**SALT ROCK WATER PUBLIC SERVICE DISTRICT  
CABELL COUNTY, WEST VIRGINIA**

**RACCOON CREEK WATERLINE EXTENSION**

**ADDENDUM #1**

**THRASHER PROJECT #101-010-1161**

DETAIL 15030-01

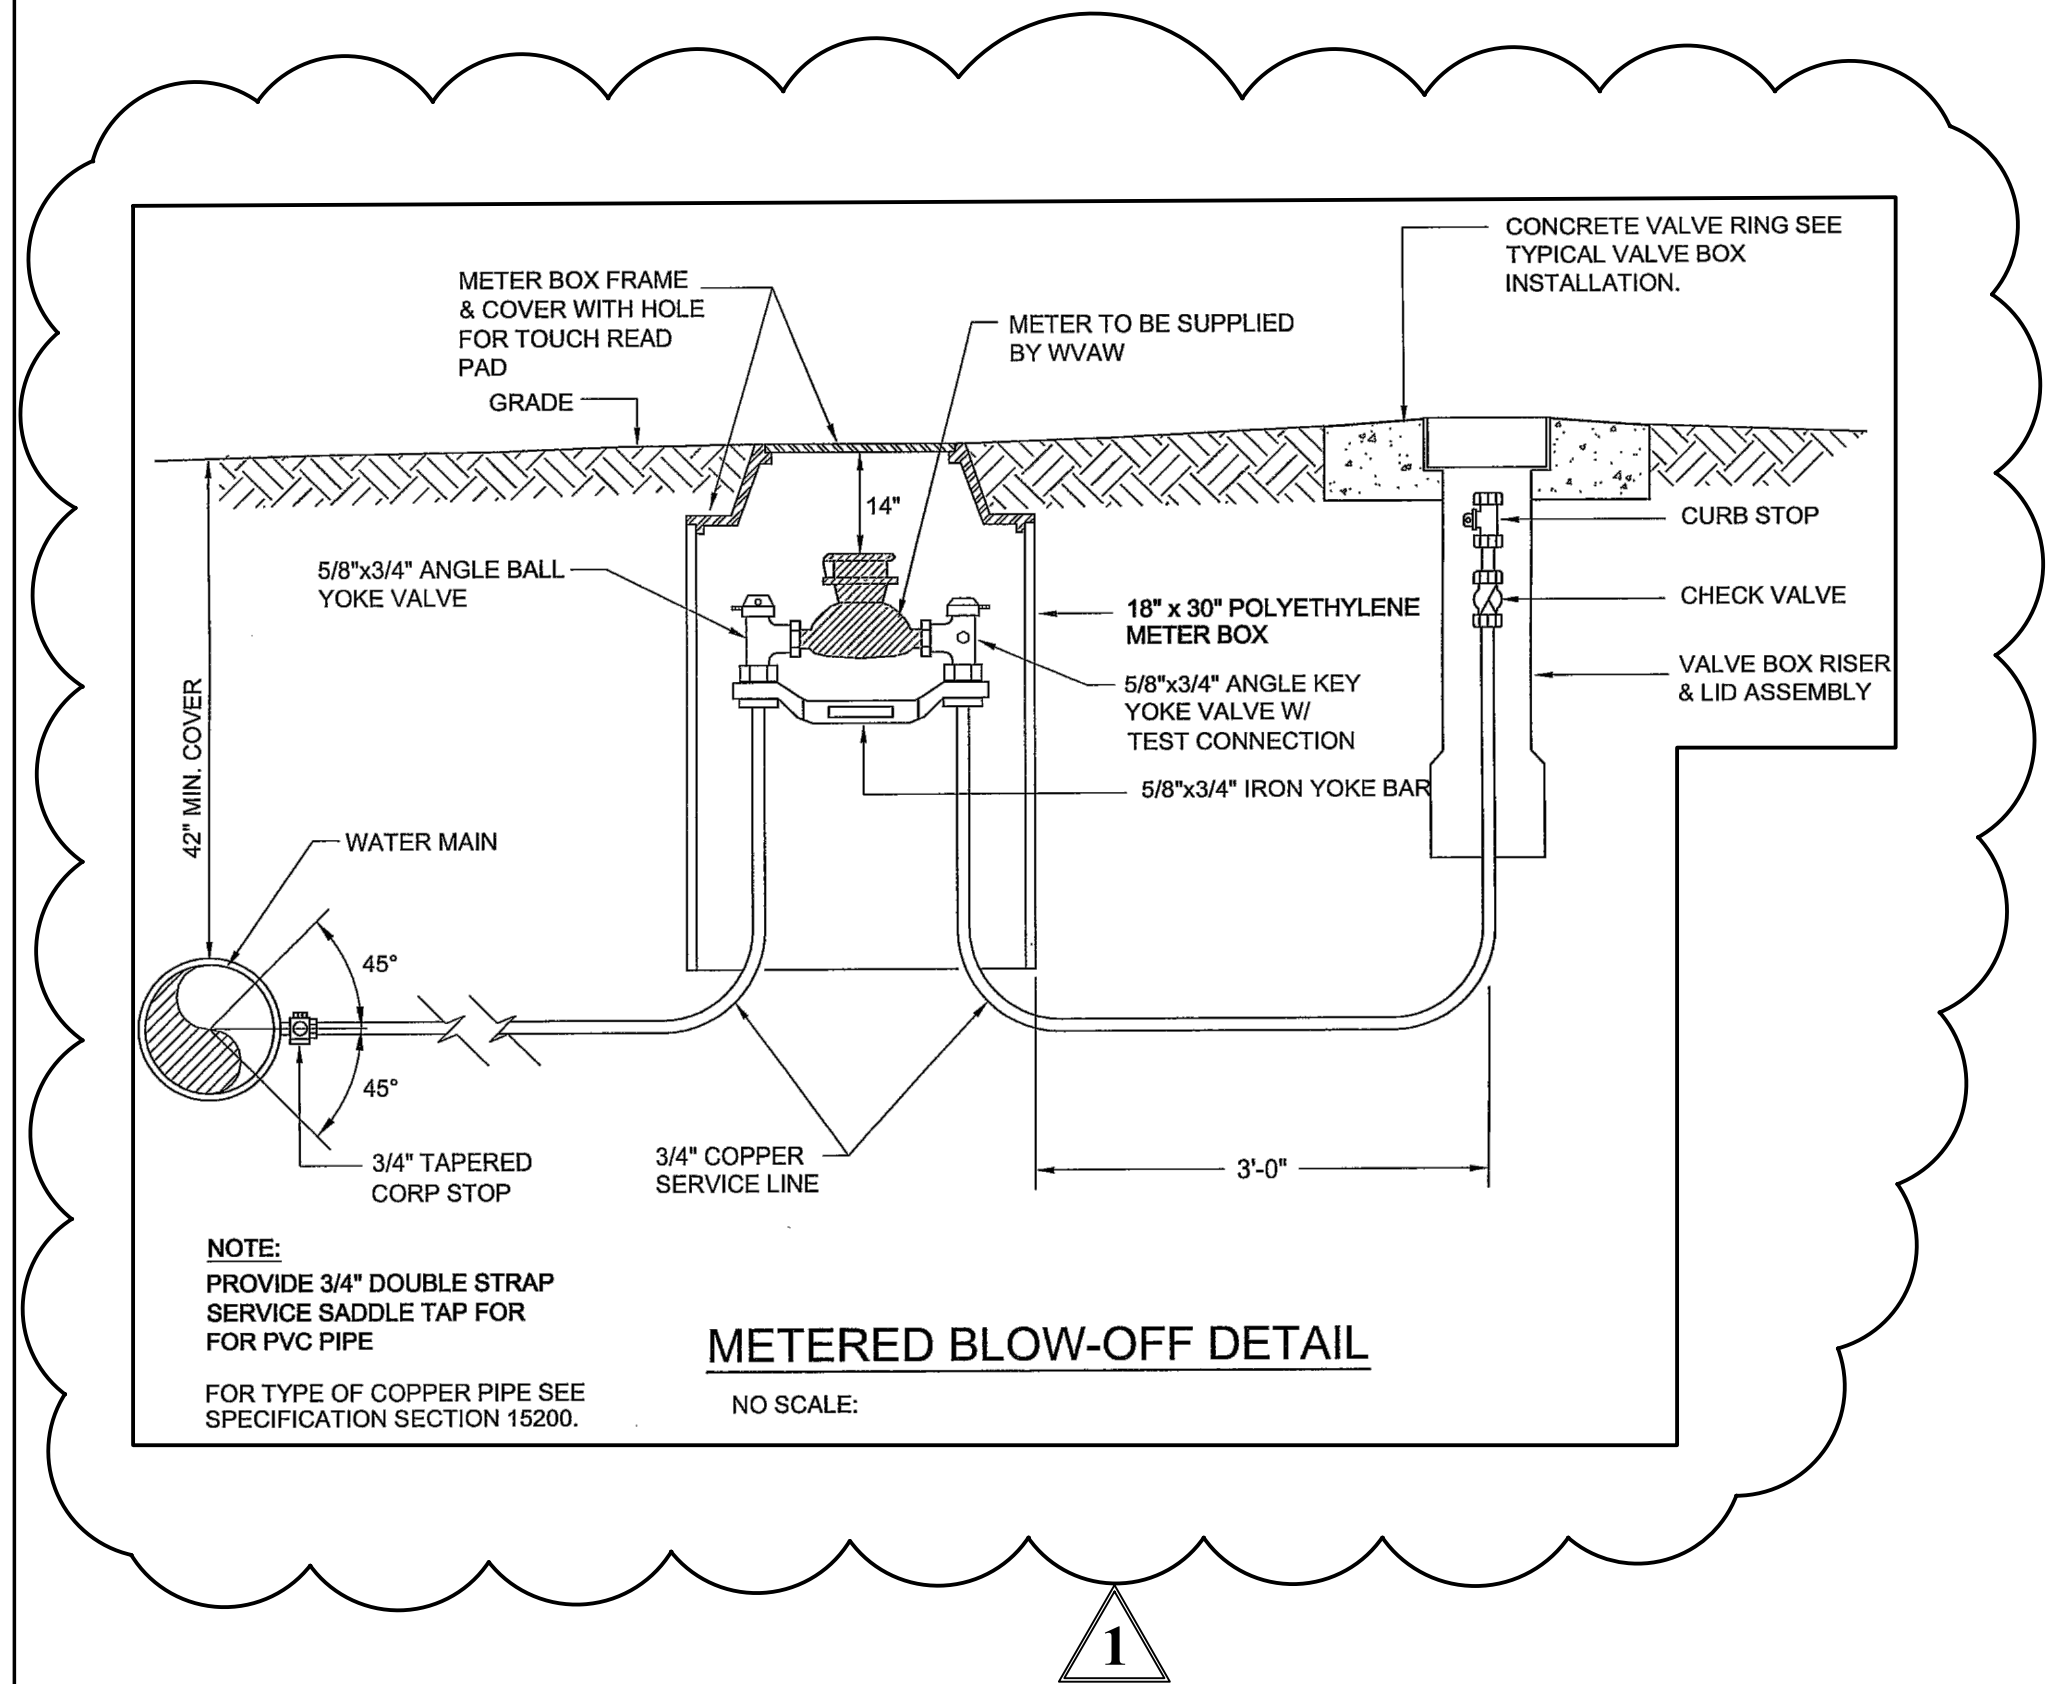
4. Will flushing of the new waterlines need to be metered?

4. Yes. The flushing and testing shall be metered in accordance with WV American Water Detail No. 15030-01, which is included with this addendum.

CAD FILE: R:\010\010-1161 WATER SYSTEM IMPROVEMENTS-SALT ROCK WATER PSD-Drawing\Contract 2\02-020-Sheet SD1 - SD6 (Standard Details).dwg PLOT DATE/TIME: 4/25/2023 2:03 PM LAYOUT: Sheet SD6 USER: bryan querrey

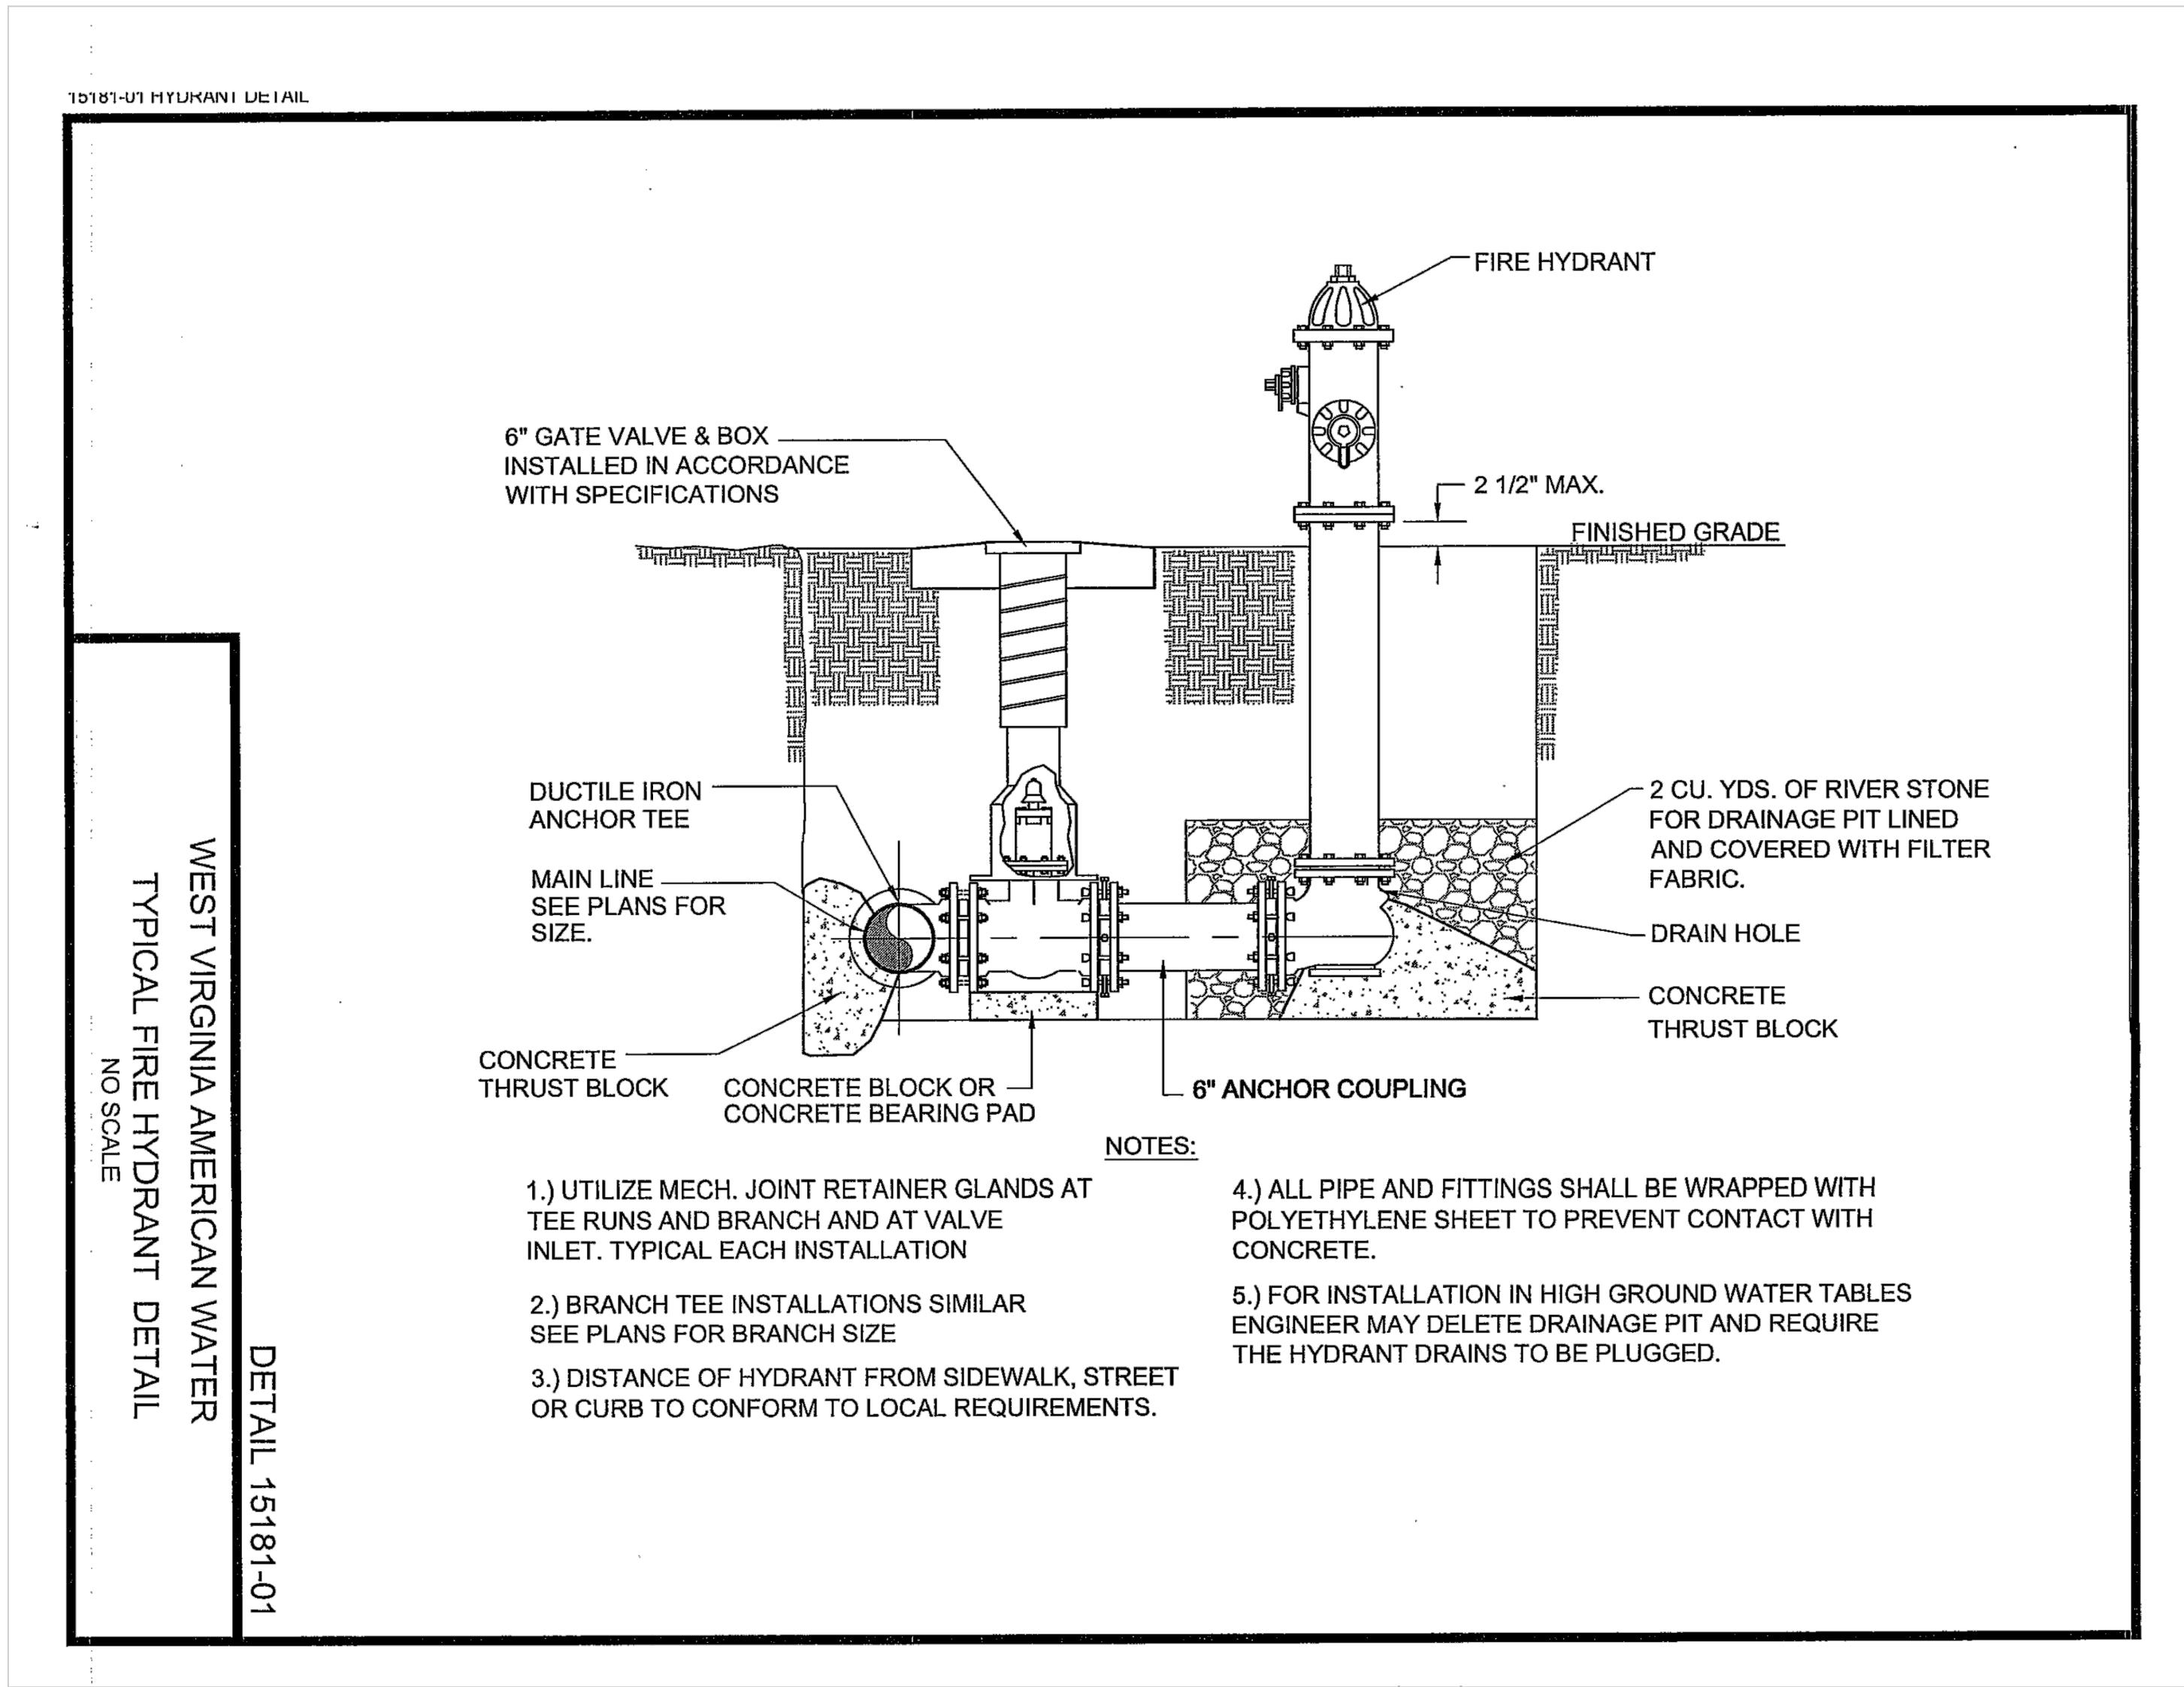
8. There is a metered blow-off assembly shown at the end of the 6" line. The bid schedule has an item for a hidden flushing hydrant. Which is required?

1	BSQ	4/2023	ADDED METERED BLOW-OFF DETAIL
NO.	BY	DATE	DESCRIPTION

8. A metered blow-off is required. The bid form has been revised to reflect this, and a detail has been added to Sheet SD6 included with this addendum.
